Response to Submissions

South East Open Cut Project
&
Modification to the
Existing ACP Consent

Ashton Coal Operations Pty Limited

Wells Environmental Services

View from above of post-mining landform (colour by elevation) showing traditional mine rehabilitation design (top) and proposed indicative modelled natural landform design (bottom). The area shown represents completion of mining and landform reconstruction in SEOC Year 5.

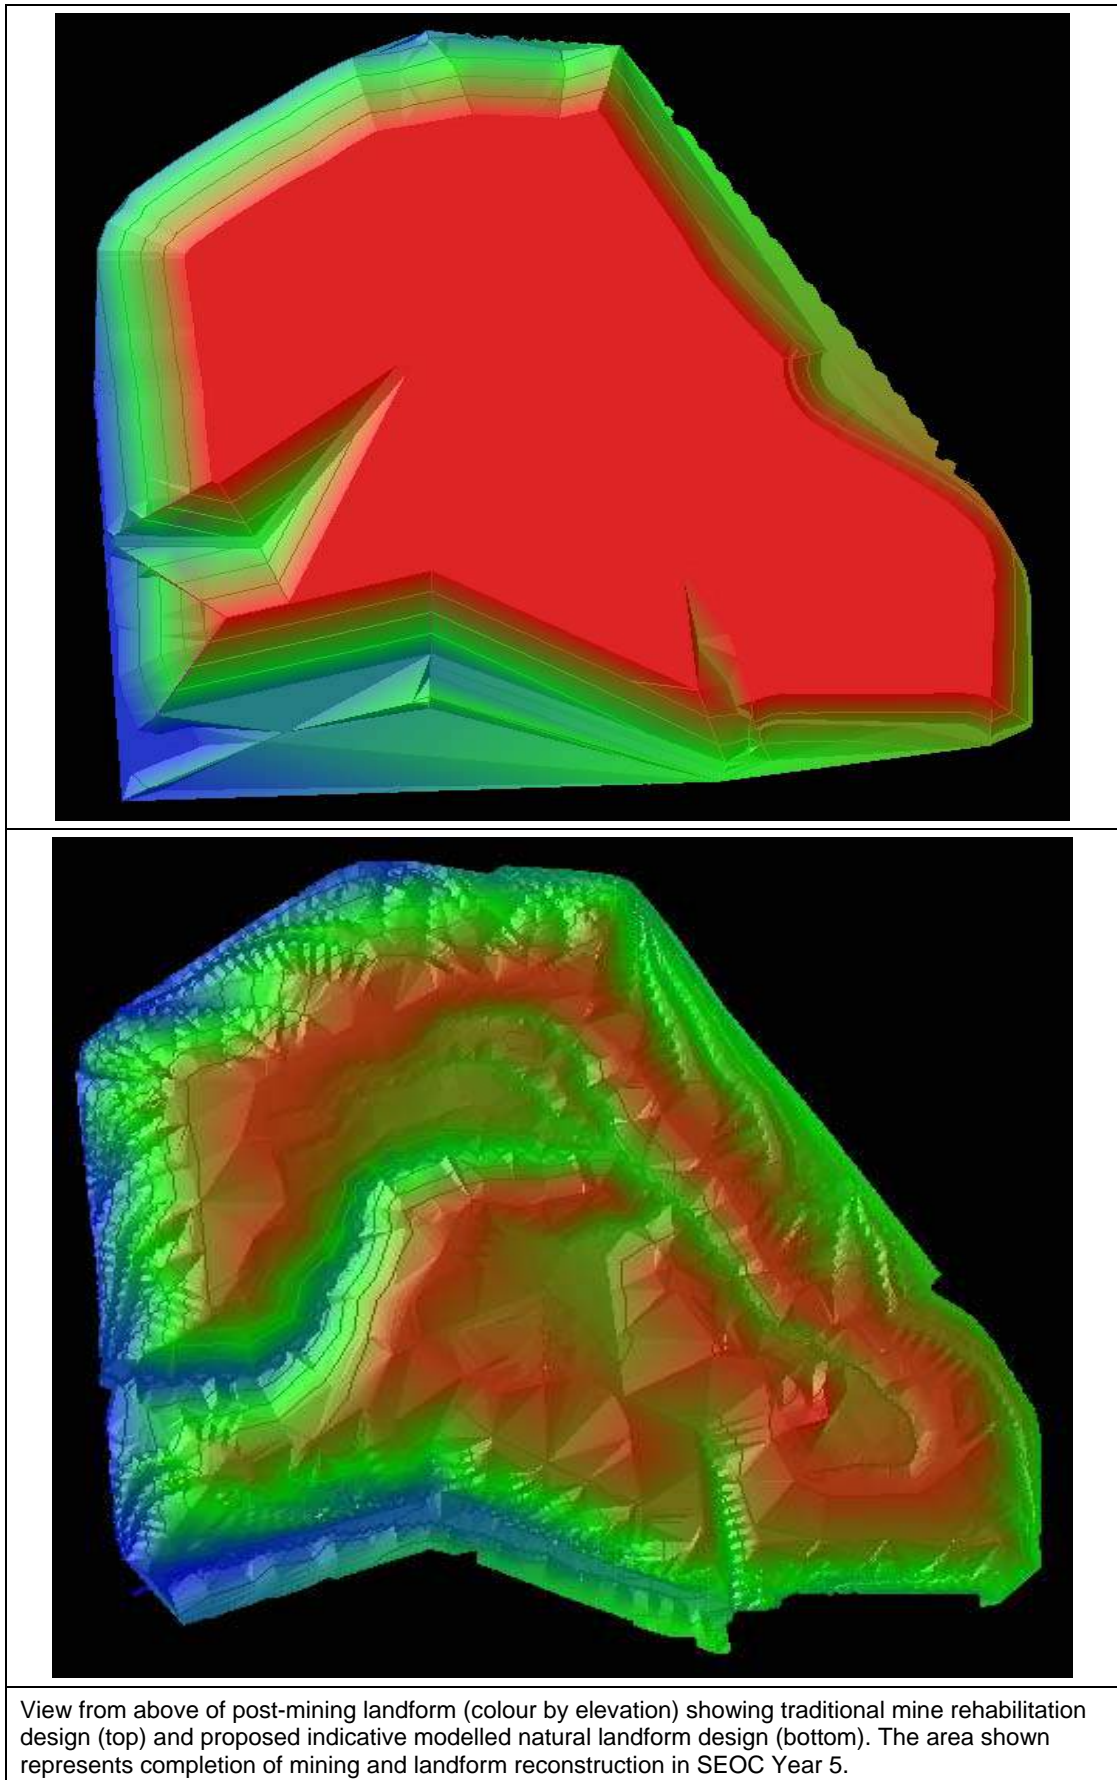
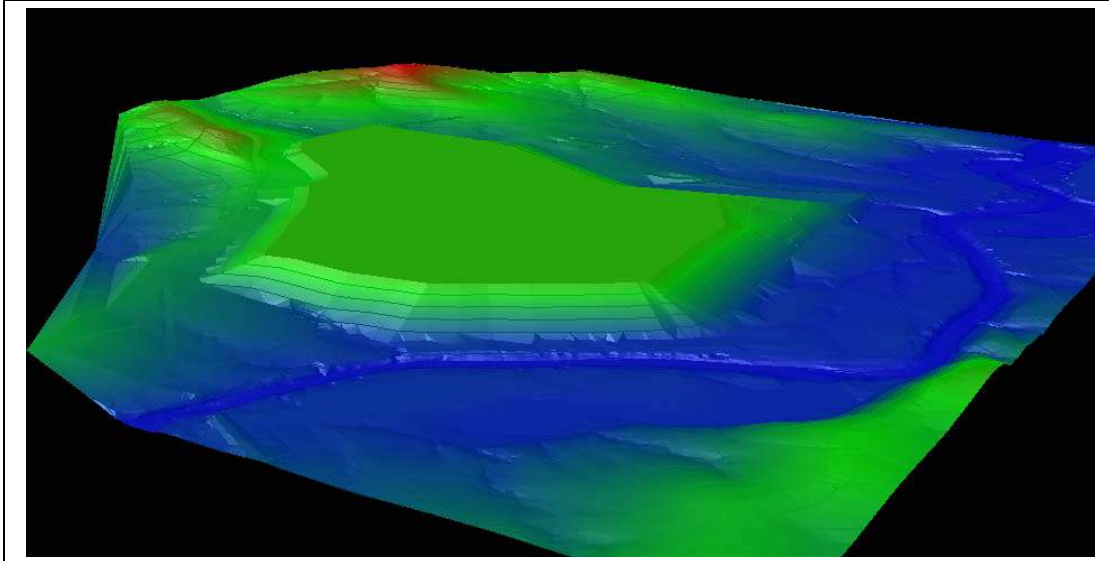
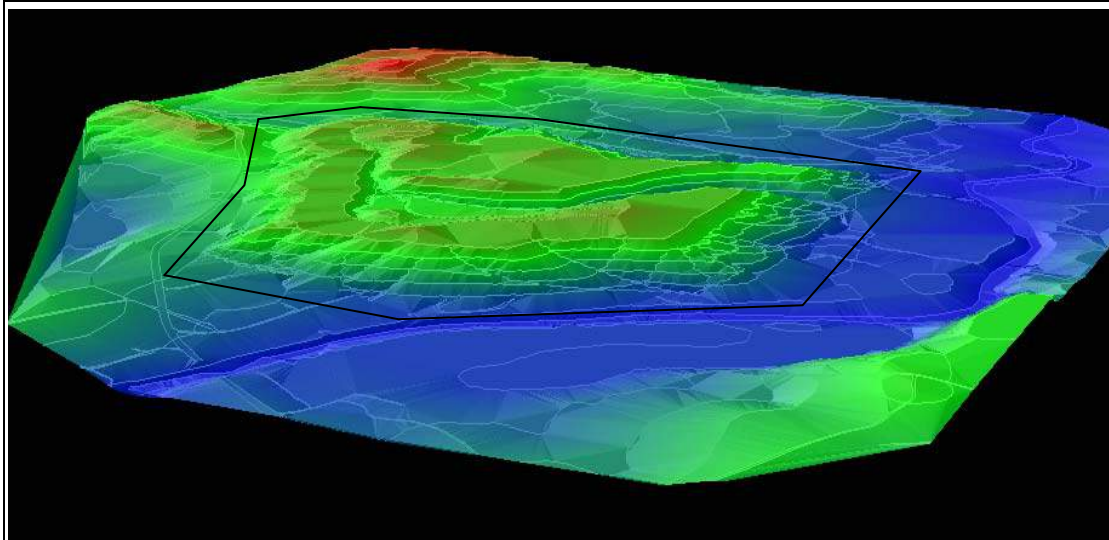
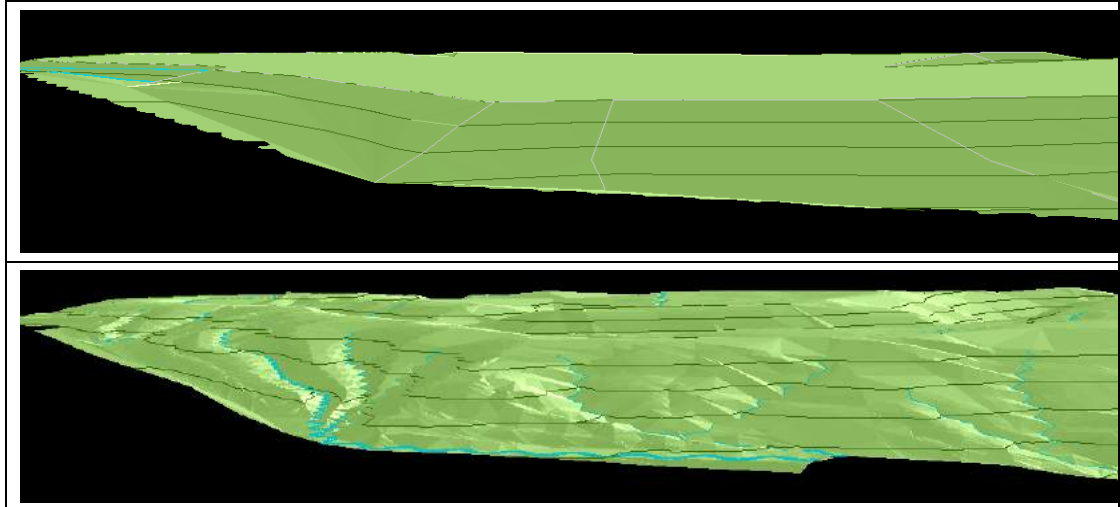
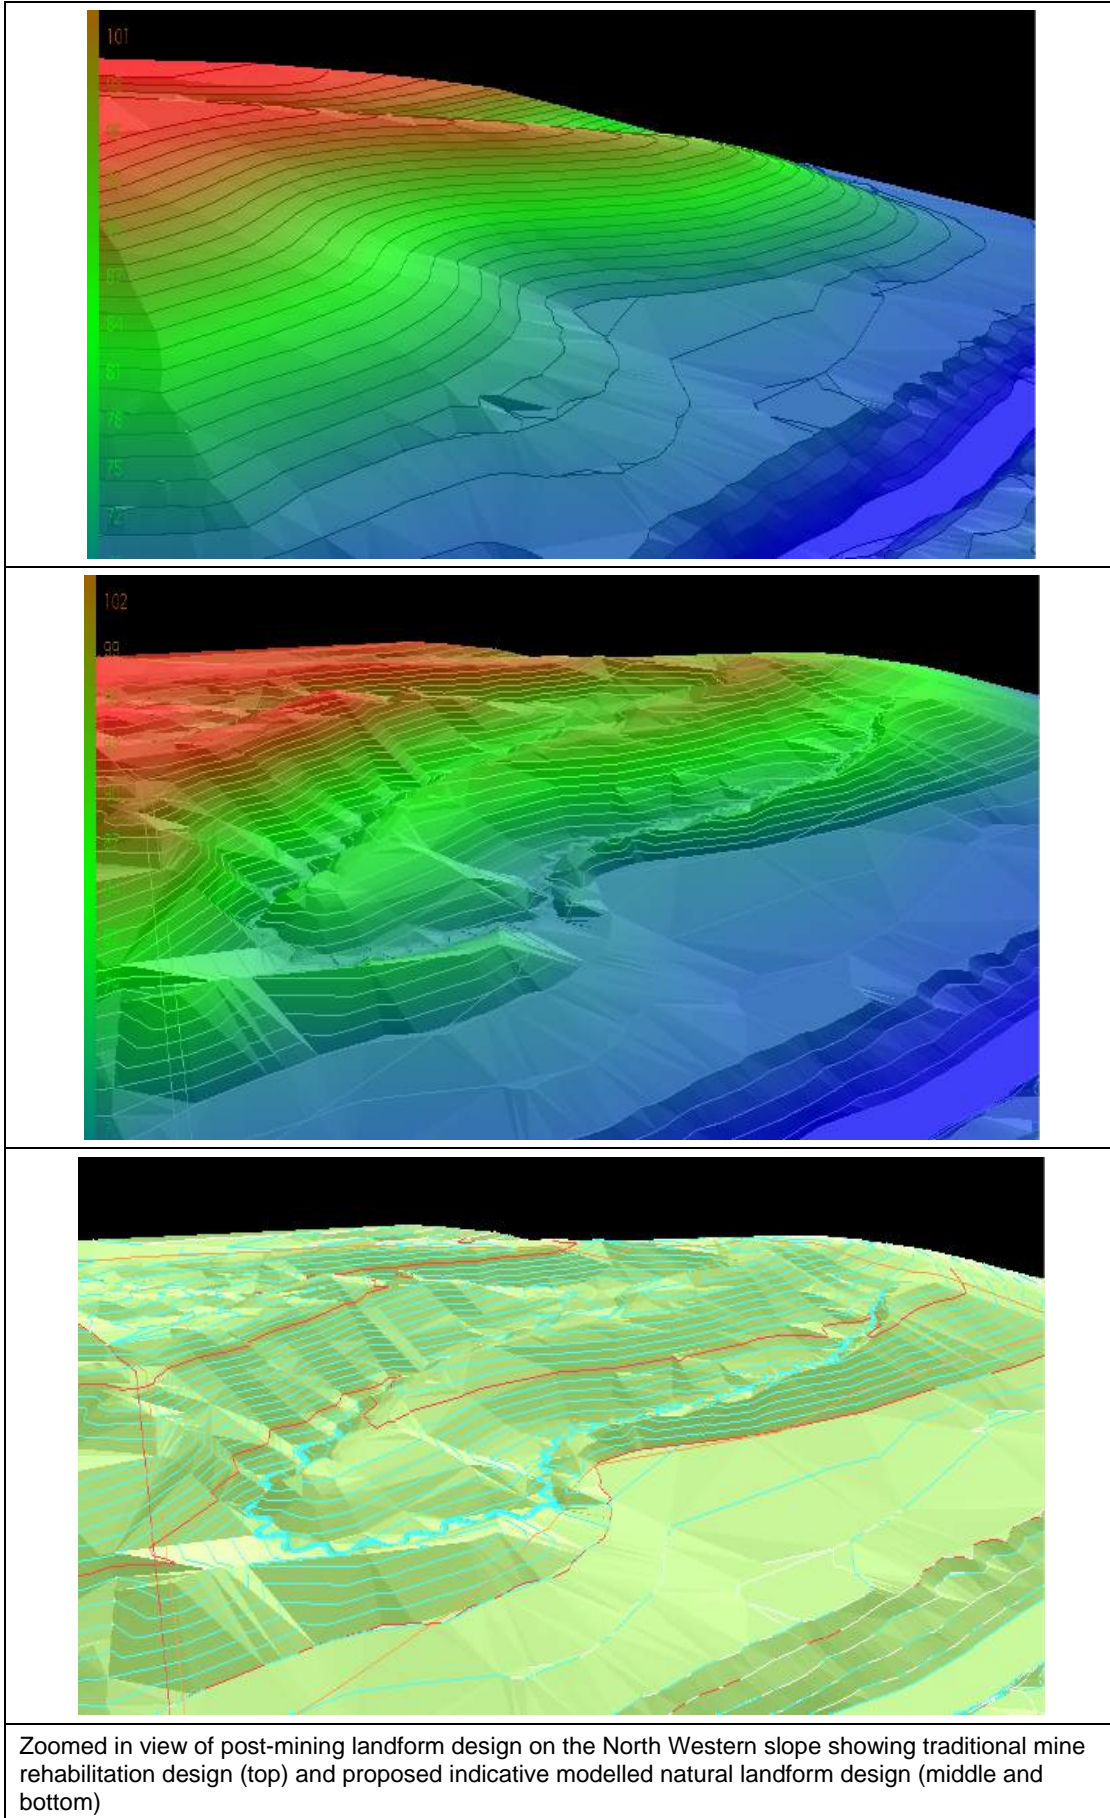
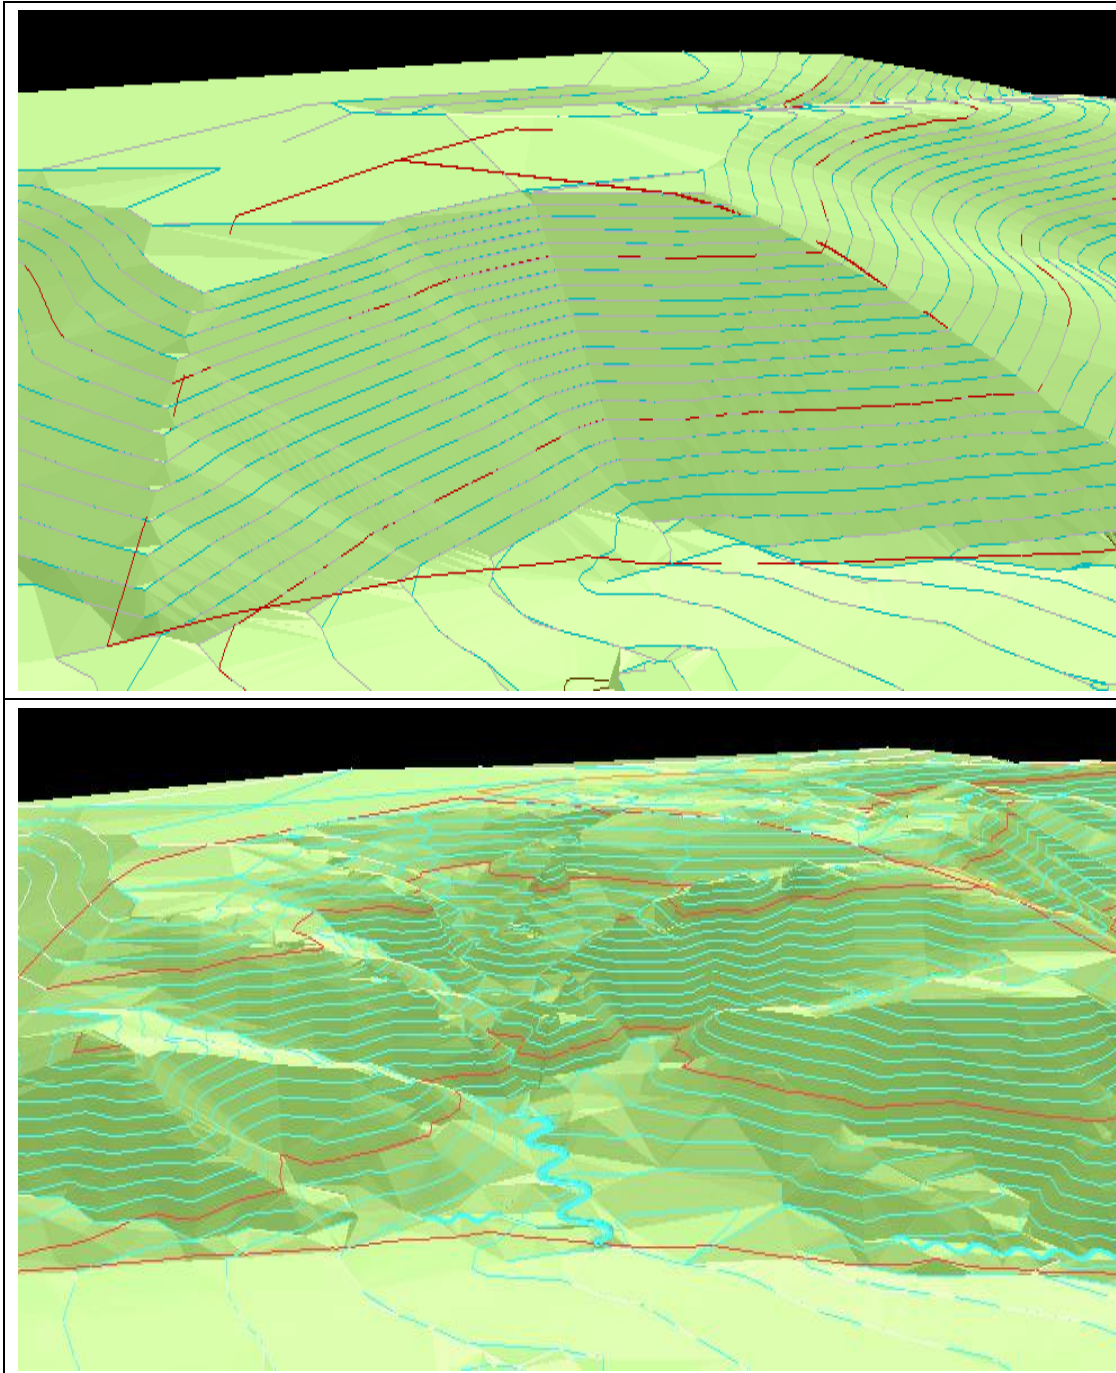
The EA proposed a final landform design based on traditional mine site rehabilitation techniques, including prescriptive slope criteria for emplacement areas in accordance with Industry and Investment NSW - Mineral Resources mine rehabilitation principles. Slope criteria historically involved emplacement designs with targeted 10 degree outer batters, with up to 18 degrees being accepted for steeper slope domains. These designs traditionally concentrate water flows to evenly placed engineered contour drains designed to break up the slope length and engineered rock lined drop structures which are designed to transport water from the slope. Over time, experience has shown that there has been persistent problems with drainage stability under these design scenarios. Growing experience is indicating that this approach is not self sustaining and has the potential to lead to long term landform instability. In addition, engineered structures are expensive to construct in the initial instance, and when not designed and constructed well, difficult and costly to maintain.

Evolving expectations from Government and Community are that final coal mine rehabilitation should be relatively natural in appearance and self sustaining. Industry is rising to this challenge and there are numerous design techniques being developed to cater for the evolving rehabilitation design expectations. ACOL has been investigating the implementation of a method developed in America over the last ten years called Geofluv. This works on fluvial geomorphic principles to design a stable final landform which is also natural in appearance. The fundamental concepts of the Geofluv approach to stable landform design are taken from the study of the development of landforms over time, from youthful, actively eroding landforms to mature, 'stable' landforms. The approach has critical input factors that measure and integrate the effects of local variation in climate, earth materials, and vegetation that define local landform stability against erosion. This is achieved by collecting empirical measurements from stable landforms in the area of interest and using these as inputs to the design. This approach provides a high degree of certainty that the GeoFluv landform design will perform similarly to the stable, natural landform.

ACOL has engaged the founder of Geofluv to undertake the design for the environmental bund and the final landform design for the SEOC.

An illustrative comparison of the two approaches (i.e. traditional versus Geofluv) is shown below, including examples of reconstructed mining landforms using this approach. More detailed information on the use of Geofluv and other examples of its use are available at: www.carlsonsw.com.
